Errata Documentation

Product	Part Number	Description	Status
PCI 9030	PCI9030-AA60PI	176-pin PQFP Package	Production Released Silicon
PCI 9030	PCI9030-AA60BI	180-pin μ BGA Package	Production Released Silicon

Document	Revision	Description	Publication Date
PCI 9030 Data Book	1.2	Data Book	December 2001

Block Diagram of one possible work around implementation

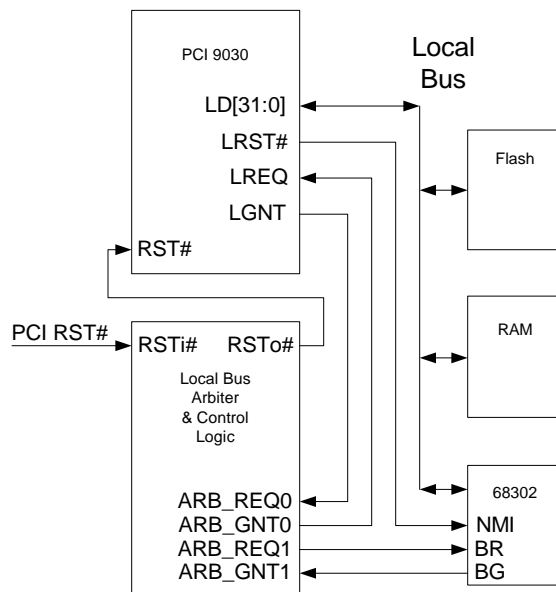
Problem: The PCI 9030 drives the LA[27:24] address pins (which can be configured as GPIO[4:7] pins after PCI reset completes), and Non-multiplexed mode LD[31:0] data or Multiplexed mode LAD[31:0] address/data I/O pins, low during PCI reset rather than to high impedance state. This may result in bus contention if other devices use these signals during PCI reset. The remaining address bus signals, LA[23:2], as well as the LBE[3:0]# byte enables, are floated during PCI reset.

4. Create external logic that controls the local bus arbitration and captures PCI RST# to provide a conditioned RST# signal to the PCI 9030. The basic concept is to always request the local bus from the PCI 9030 and only grant the bus to PCI 9030 when it informs the system that it needs the bus by negating its LGNT pin. Below is a detailed description of this workaround.

Below is a block diagram of one possible implementation, showing only the relevant signals. The necessity of this workaround is required only if the user does not want PCI reset to generate a system/board reset. Because the PCI 9030 drives the LA[27:24], LD/LAD[31:0], and LRST# pins low as long its RST# is asserted, bus contention will occur on the local bus if other local bus devices are using the bus at that time. The workaround concept is as follows:

- Capture the PCI RST#,
- “give” the local bus to the PCI 9030;
- assert a reset pulse on the PCI 9030 RST# pin for a minimum of 2 rising PCI clock edges;
- wait for the PCI 9030 to process its RST#;
- “take” local bus control back from the PCI 9030, resume normal local bus activity, prepare for the next PCI RST# after it negates

The workaround requires the PCI 9030 RST# signal to be asserted for a minimum of two PCI rising clock edges. If you only have access to the Local clock then you would need to determine the minimum frequency of PCI operation. A close approximation is - Minimum PCI frequency = $2.01 \times 1/\text{period}$, where period is the amount of time you assert RST#. If the PCI clock is available for use, the design can be constructed to ensure RST# is asserted for two rising edges, and using the PCI clock will allow the design to work down to 0.0 MHz. LREQ may be asserted before, during and/or after RST# and LRST# assertion.
